**ADDENDUM TO INVITATION FOR BIDS**  
**Humboldt County Office of Education**  
**Proposition 39**  
**Administration Building Furnace Project – Re-bid**  
**Bid No. 17-023**

**Addendum No. 3**  
**October 24, 2017**

Green oval indicates staging area for equipment and materials (image adapted from drawing A1.01)

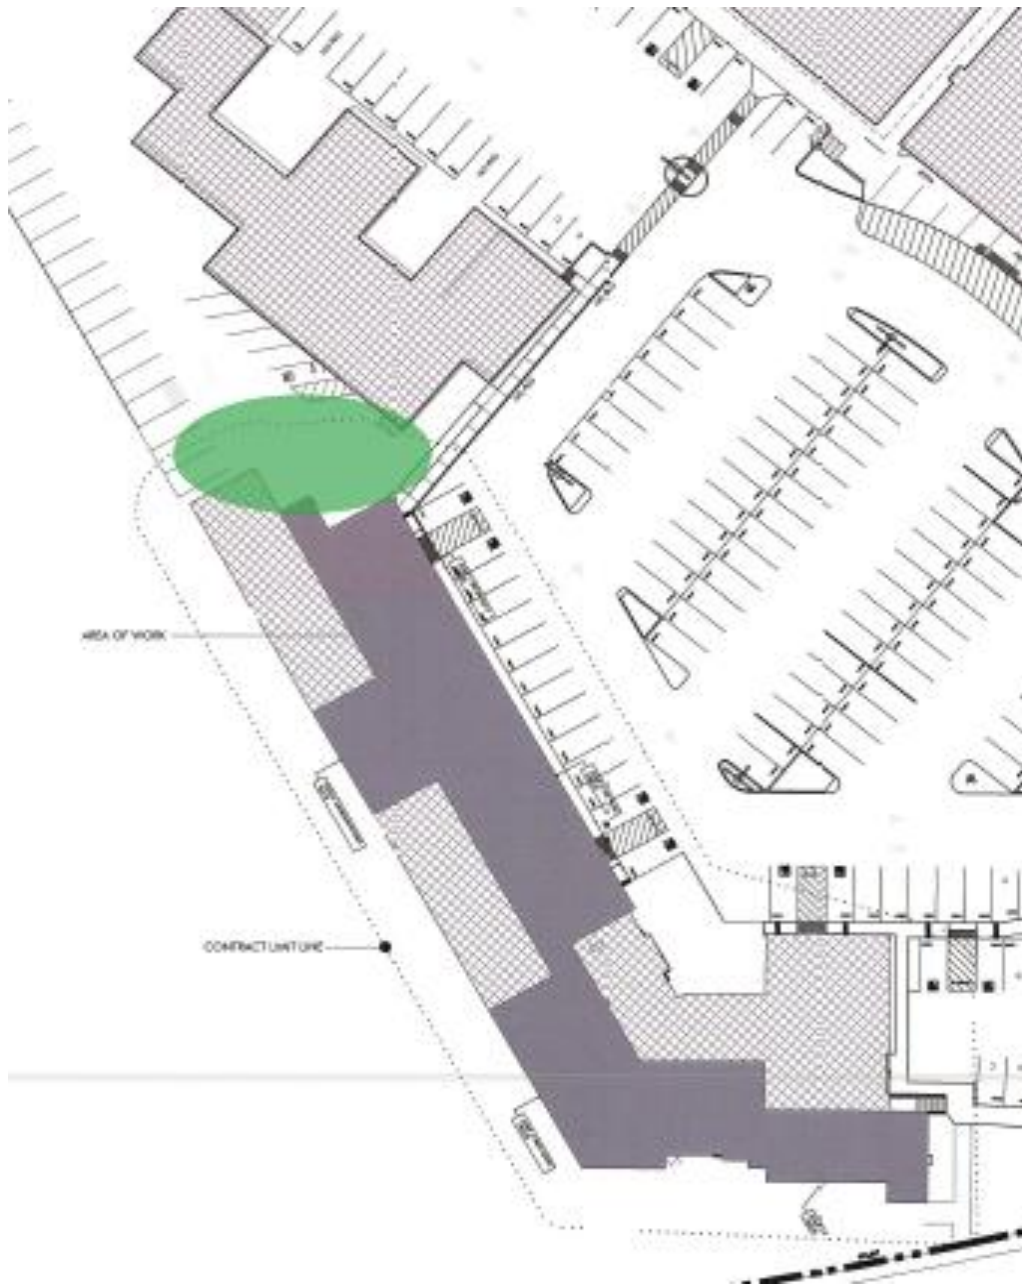
2. Disregard the note on drawing A3.01 indicating new R-19 batt insulation for the entire floor of the building. Also, no installation of insulation is to be included in the scope of work in the attic space.
3. An area for staging of equipment and materials for this project has been identified at the north end of the main Administration Building – see green oval shown on attached drawing. Please note that this area will only be available during the installation window from June 18 through August 10, 2018.
4. In Addendum No. Two, “ Item 2.00 – Drawing Clarifications”, part 2.B - the sentence should read: "Where ductwork removal or demolition work occurs in the original ceiling, the resulting holes should be repaired and sealed in a workmanlike manner, using gypsum board or other suitable material, to prevent conditioned air from leaking back into the attic."
